TOWN OF NISKAYUNA
Planning Board and Zoning Commission

Agenda

August 29, 2022

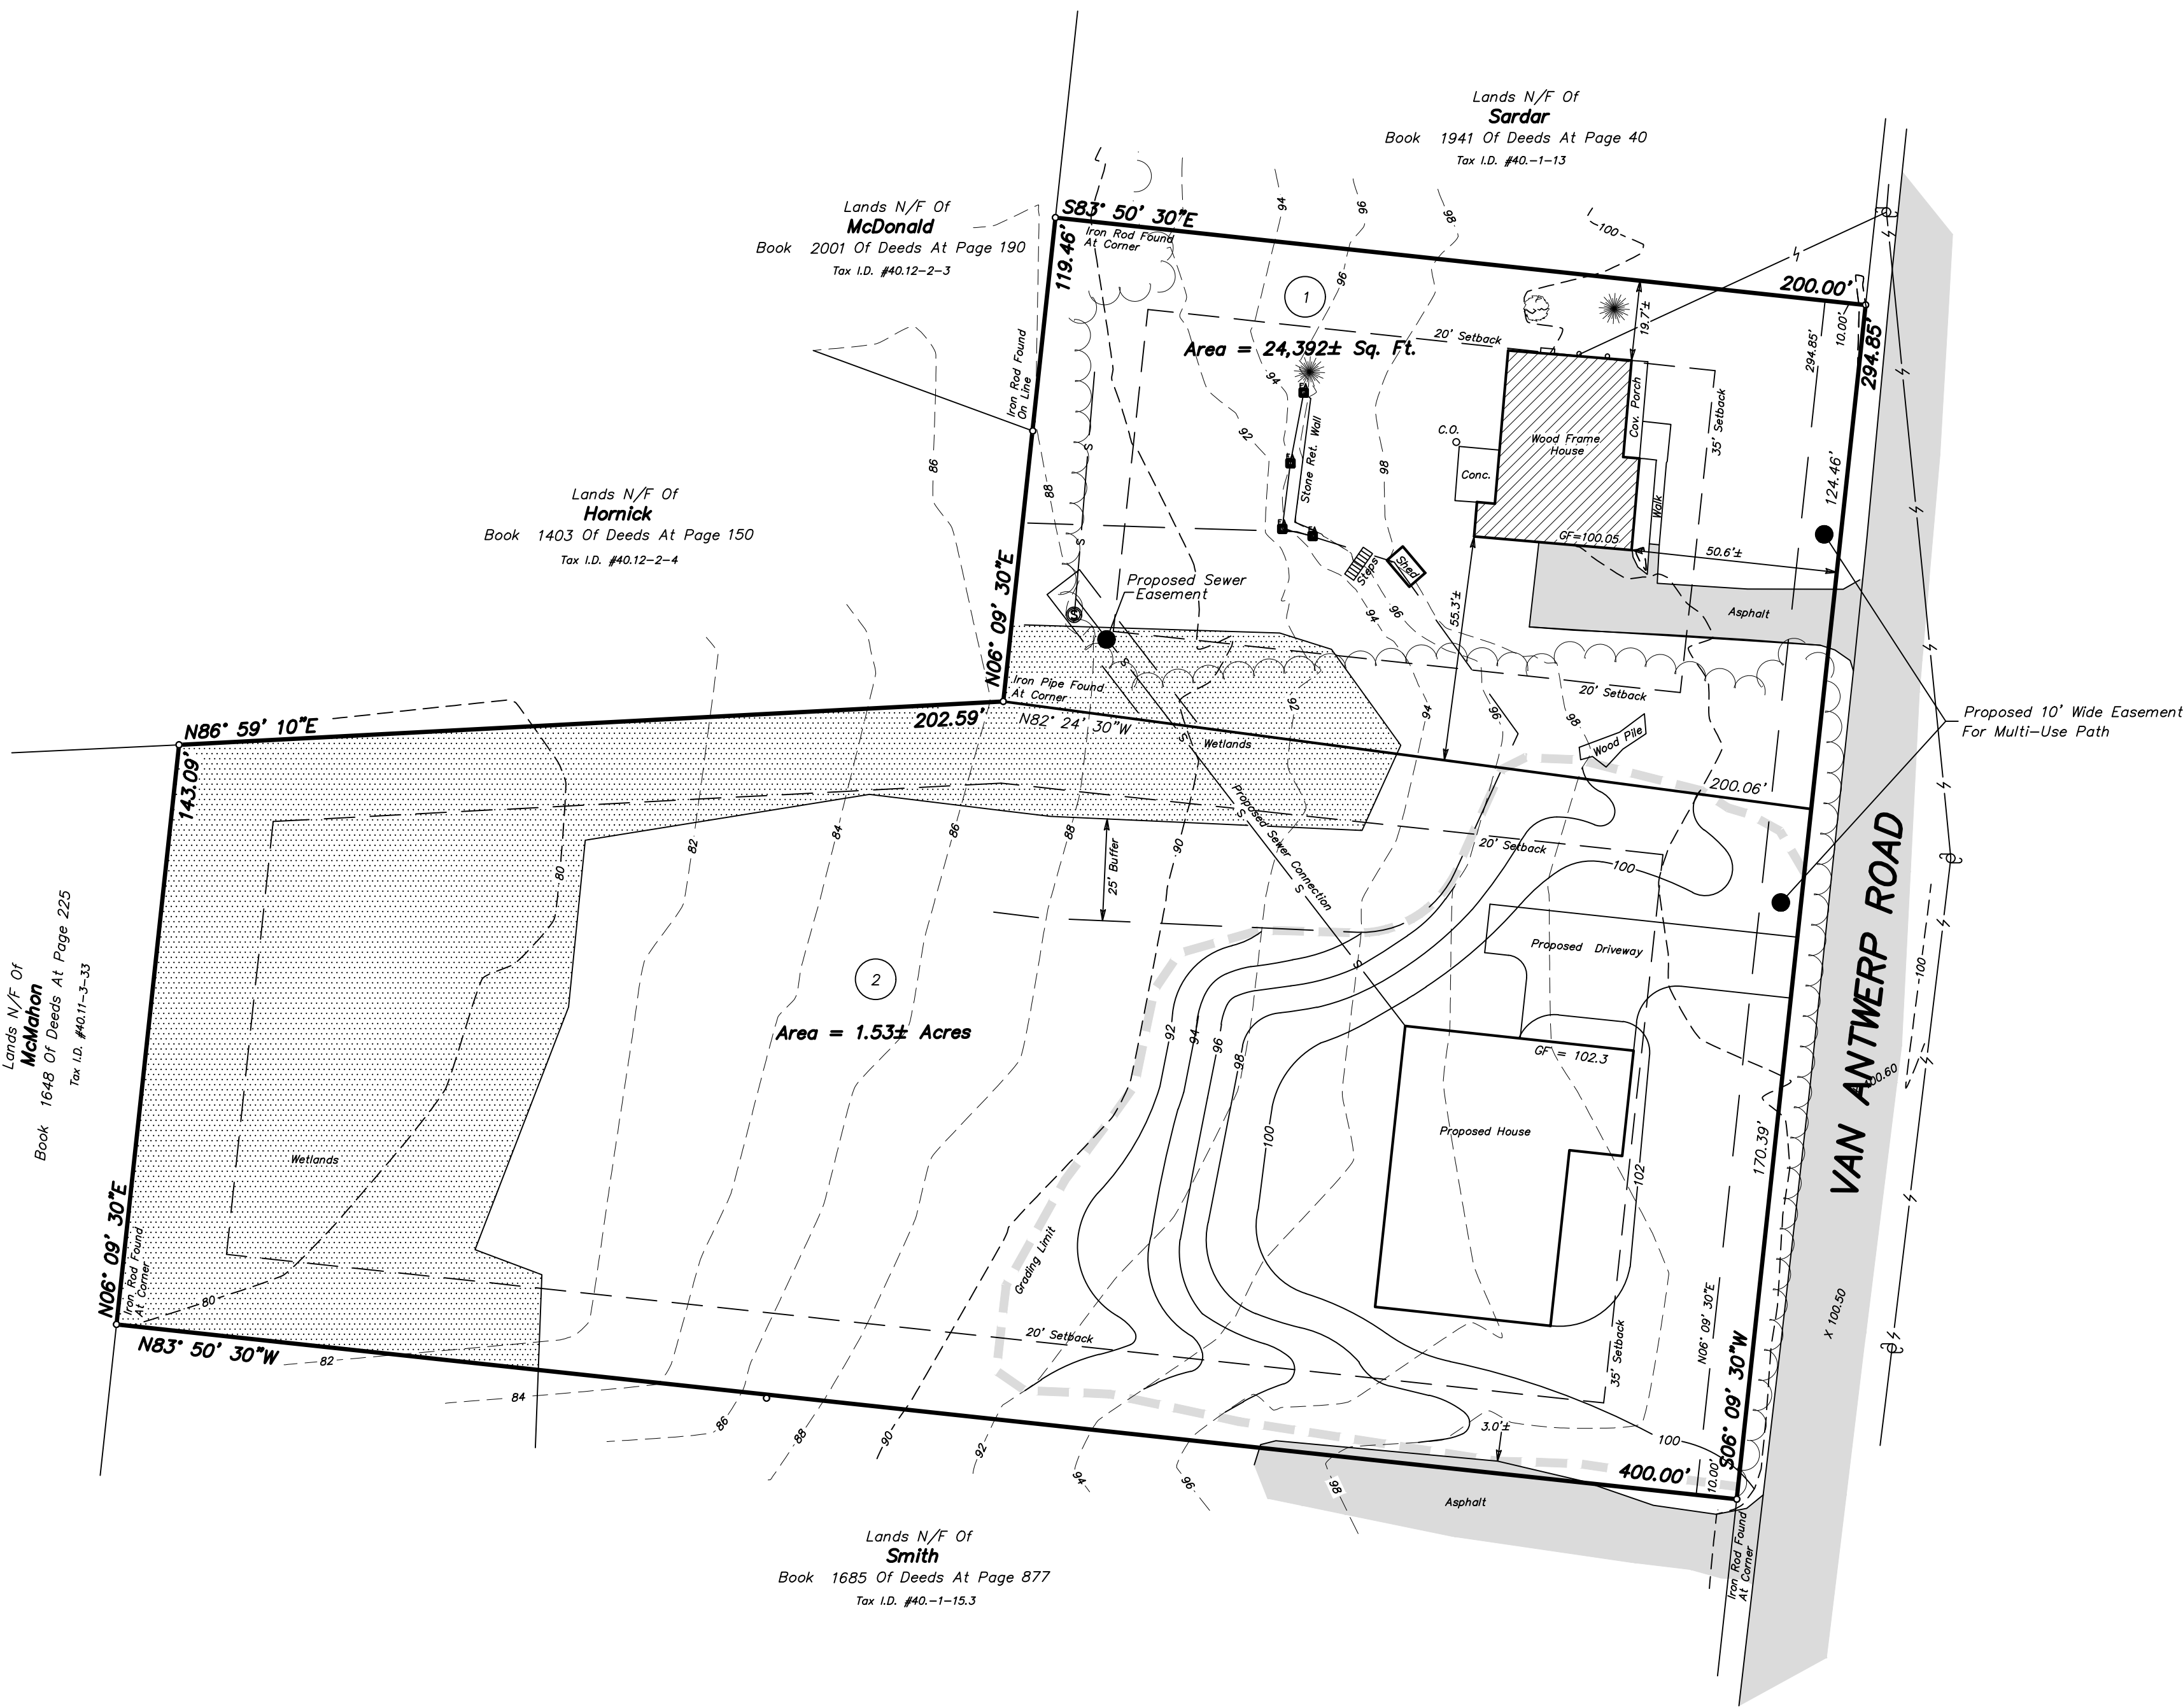
1. Work with the Tree Council to preserve as many trees as possible and review limits of clearing
2. Include a 10' wide easement along Van Antwerp for a future multi-use path
3. Revise site plan so there is no disturbance to wetlands and no grading or disturbance to the 25' buffer to the wetlands
4. Utilize energy conservation practices and sustainable energy for new buildings

The applicant is to provide an updated site plan drawing for the 8/29/22 meeting.

The Tree Council walked the site and noted the area has old forest characteristics, large trees, snags and down logs. They also noted there are many large trees of significance. See list and photos below. They recommend the Planning Board require adding trees that have a diameter at breast height of greater than 25 inches to the subdivision plan so that the Town can work with the developer to avoid the large trees and retain as much forest patch as possible.
